CITY OF ALBUQUERQUE

Re: Baca Townhomes
112 Princeton Drive NE
Traffic Circulation Layout
Architect's Stamp 03-01-2022 (K16-D094)

TRAFFIC CIRCULATION LAYOUT

SHEET
TCL

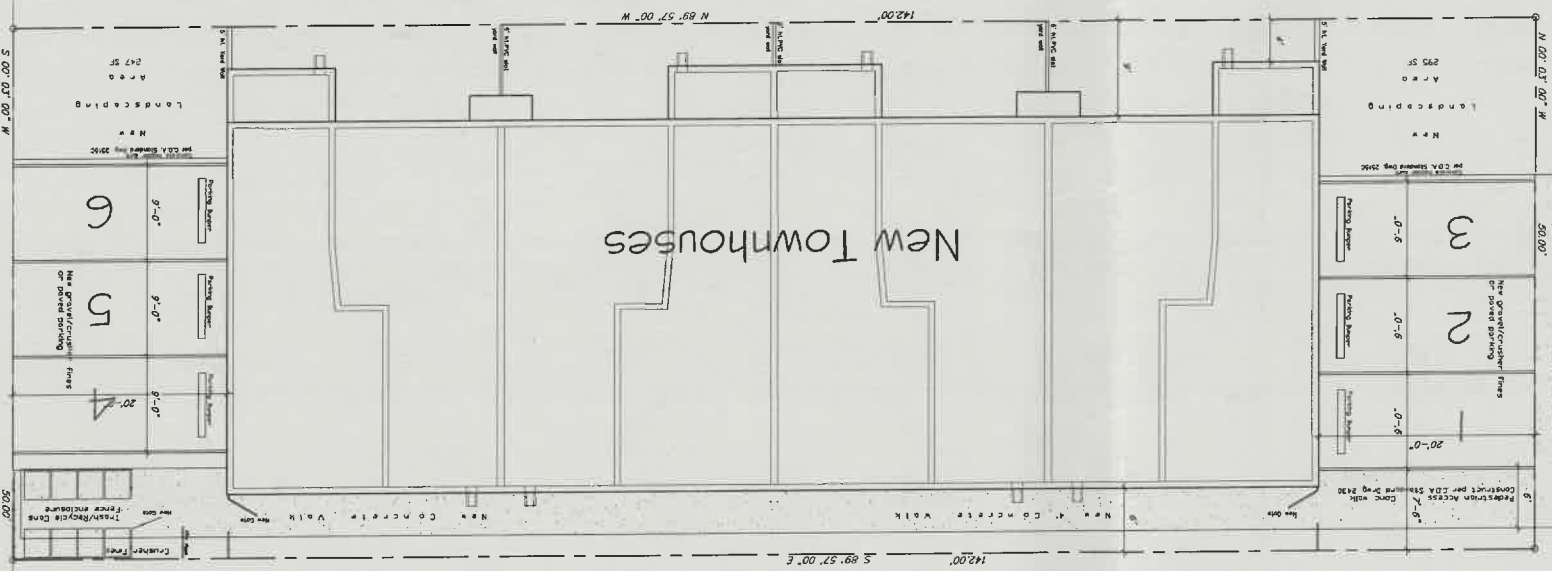
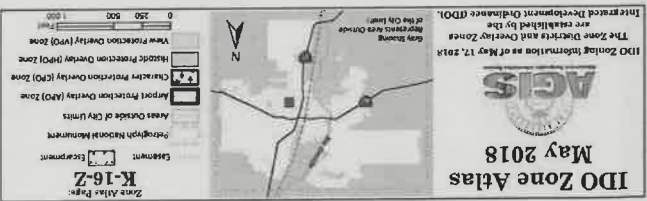
Unused Curb Cuts must be replaced w/ sidewalk, curb & gutter per City standard drawing 2430 & 2415A
All broken or cracked sidewalk must be replaced with sidewalk and curb & gutter per City standard drawing 2430 & 2415A

Unused Curb Cuts must be replaced w/ curb & gutter per City standard drawing 2430 & 2415A
